WBC Planning Application 261624 – OBJECTION

Land West of Hogmoor Lane, Hurst: Permission in Principle application for the proposed erection of a maximum of 2 no. dwellings (or a minimum of 1 no. dwellings), including formation of an access from Hogmoor Lane.

Submitted by: A A Butler

Date: 29/07/2026

2.4 Recorded Flooding

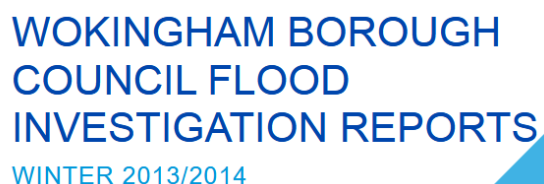
(B) The screenshot below from the Applicant’s FRA “**2.4 Recorded Flooding**” displays an attempt to create a misleading impression of “**no historic flood events in the vicinity of the site**”. The Applicant’s FRA fails to mention easily found and relevant official WBC flood reports and previously submitted Interested Party irrefutable flooding evidence submitted both with App: 240853 and App:260353 – both applications directly relevant to WBC Site Ref: 5HU030. By association with what should be respected organisations, statements are made which misleadingly imply there is no local flooding history.

WBC as LLFA still agree with these “no liability accepted” statements which wrongly imply no flooding history or risk, made by FRA contractor Calibro on the Applicant’s behalf?

It would appear there has been a lack of due diligence on the part of the Applicant’s FRA Contractor to either properly research the flooding history of both the site and surrounding area or any attempt to either acknowledge, or present the local flooding history as it is.

Figure 8- 1: Source-Pathway-Receptor mapping for Hogmoor Lane and Property 1 in Hurst

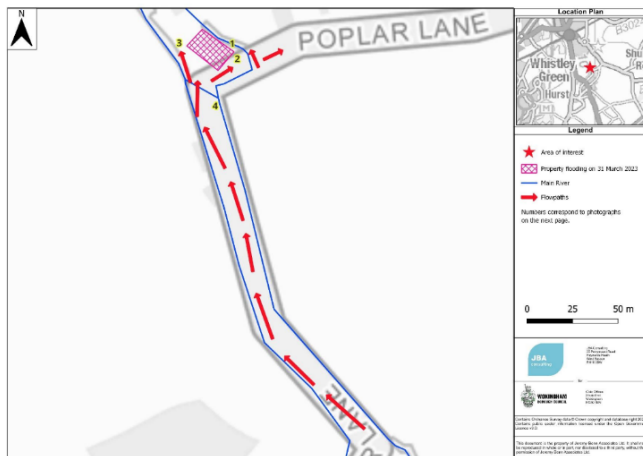
Screenshot of “S-19” Figure 8-1 (left below) shows the location of at-risk White Rose Cottage relative to 5HU030 boundary 175m to the south. S-19 Figure 8.2 comprises four photos of the Hogmoor/Poplar Lane flooding around White Rose Cottage. The S-19 report also includes a photo of foul sewer surcharging in Hogmoor Lane 50m from 5SU030 site adding to and contaminating the flooding (after the rain has ceased) and flood risk across the proposed Hogmoor Lane site entrance.

The Calibro FRA Figure 2.2 screenshot (right above) makes it appear there is a risk free surface water drainage path north from the site via the “Kayersbridge Brook” with no mention of the increased “S-19” indicated downstream flood path risk both to near neighbours and particularly White Rose Cottage, where the ditch distinctively kinks around the at-risk property. The FRA really needed to address WBC S-19: [Appendix A “Addressing flooding in Hurst”](#).

Until the agreed water hold-up/storage and derestriction recommendations of the 2024 “S-19 report” have been implemented, and been proved to improve flow into the Twyford Brook, surely no more development increasing surface water run-off in The Green Man and Stow Streams towards White Rose Cottage should be permitted?
